# Access Compliance Report

## Public Rights-of-Way

### (Curb Ramps)

Intersection ID: 5946	Main Street: CONIFER_CR	Cross Street: FAIRES_FARM_RD	Location: S
ADA ID: 2B7460C336C0	Ramp Type: Perp	Initial Pass/Fail: Fail	Overall Compliance: No
Severity Score: 21.25			
Codes/Mitigation Info/Possible Solution		Field Measurements/Component Compliance

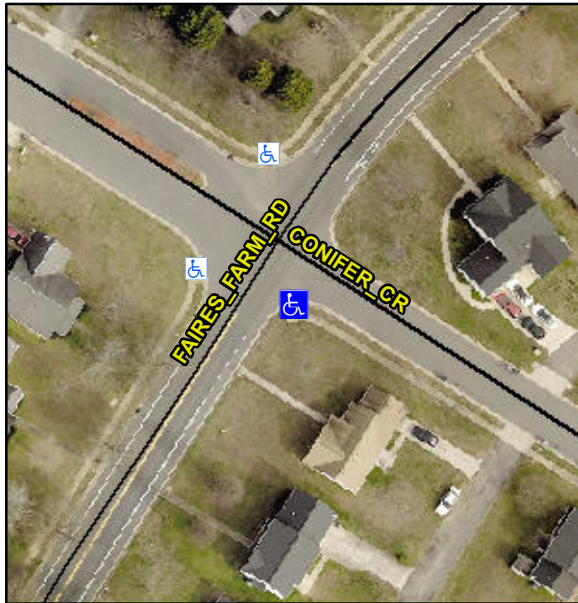
**Remove & Replace Entire Ramp.**

**Not Found, R304.5.1, R304.2.2**
